Regarding: **Block 2002, Lot 26, Borough of Hillsdale**
6 Willow Brook Road: Variance Application PZ-04-23
Ms. Selina Ramoutar, Applicant and Owner

We are in receipt of a bulk variance application, site plan, and photographs of the subject property that were submitted on or about September 8, 2023 to the Board for review.

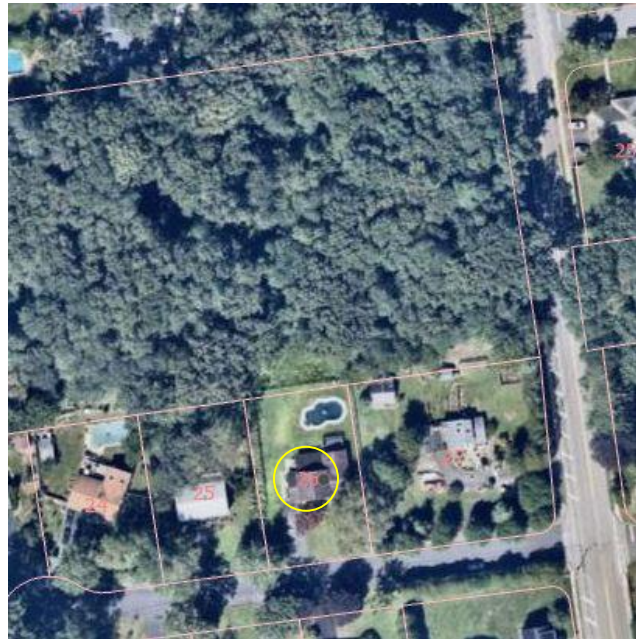
1. The applicant is responsible for providing the required testimony for the need for all variances. The positive and negative criteria must be satisfied.
2. The property directly to the north is owned by The County of Bergen as part of Wood Dale Park (see photo to right).
